ADDENDUM NO. 3
TO THE
DRAWINGS AND PROJECT MANUAL
FOR
**KISD 2025 FRP
KLEIN I.S.D.
KLEIN, TEXAS**

02/19/2026

3.5 REVISED DRAWINGS

NITSCH - ROOF PLANS - UNIT D & E & ALTERNATE #10

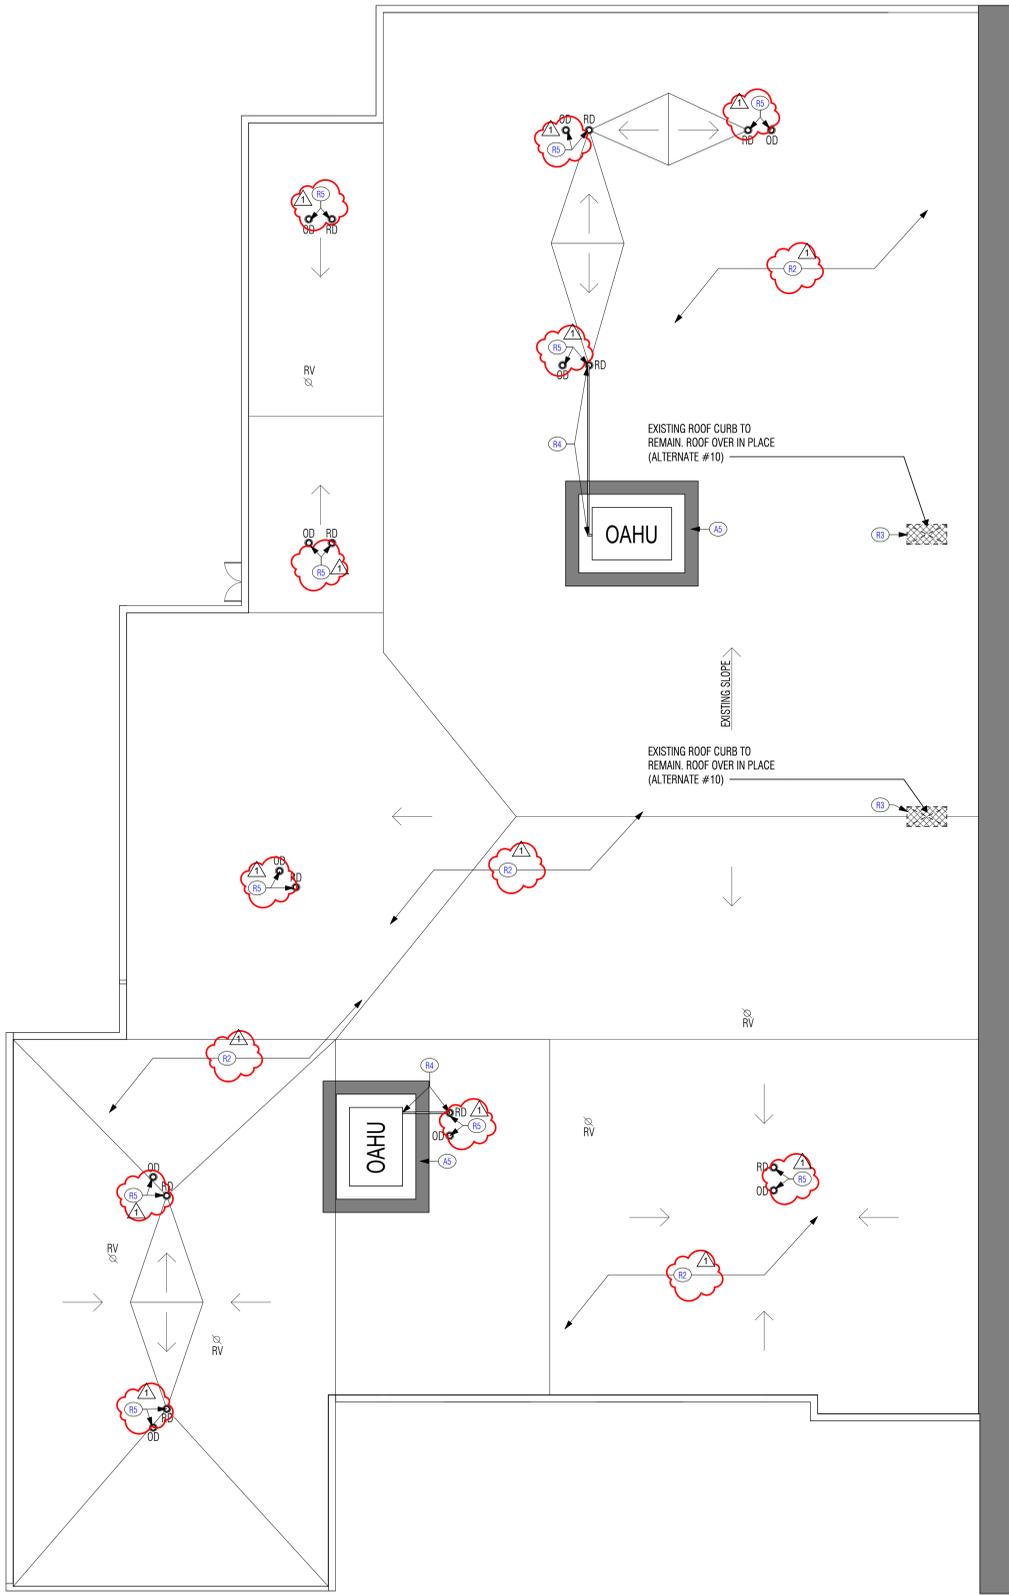
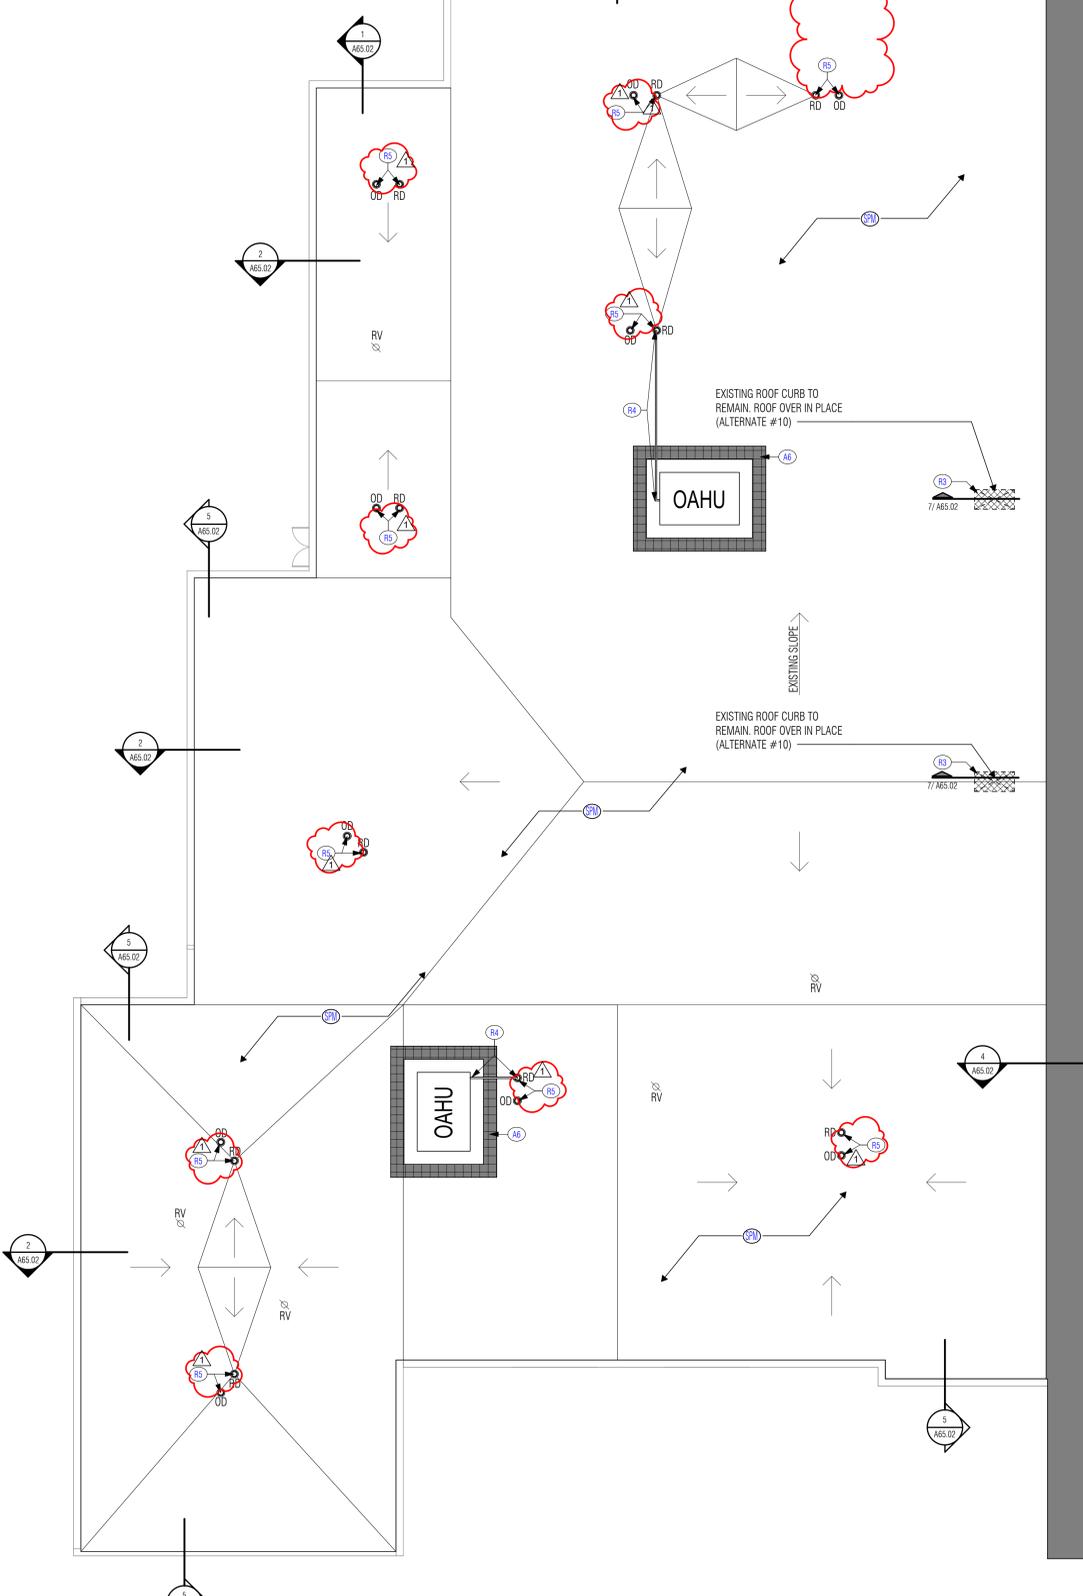
- A. Sheet Nos. A65.01 and A65.02 dated February 19, 2026 and attached hereto, are revised drawings and are hereby made a part of this addendum.

Key Value	Keynote Text
A5	EXISTING WALKWAY PAD TO BE REMOVED.
A6	PROVIDE WALKWAY PAD ALL AROUND UNIT.
R2	REMOVE EXISTING SINGLE-PLY ROOFING SYSTEM DOWN TO MTL. DECK. AND INSTALL (2) LAYERS OF 2-5" INCH POLYSTY INSULATION. 1/2" GYP BOARD AND SINGLE PLY MEMBRANE WITH 3/4" PLYWOOD BLOCKING AT THE PERIMETER. RE: 6/A65.02
R3	(ALTERNATE #10) REMOVE EXISTING ROOF CURB AND INSULATION AS NEEDED TO INSTALL NEW METAL DECK. METAL DECK SIZE AND PROFILE TO MATCH EXISTING. RE: 7/A65.02
R4	REMOVE AND REINSTALL CONDENSATE LINES. REMOVE AND RETAIN PIPE SUPPORTS. REINSTALL SUPPORTS PROVIDE PADS AT EACH SUPPORT.
R5	REMOVE AND REPLACE ROOF AND OVERFLOW DRAINS.

R3	REMOVE EXISTING ROOF CURB AND INSULATION AS NEEDED TO INSTALL NEW METAL DECK. METAL DECK SIZE AND PROFILE TO MATCH EXISTING. RE: 7/A65.02
----	---
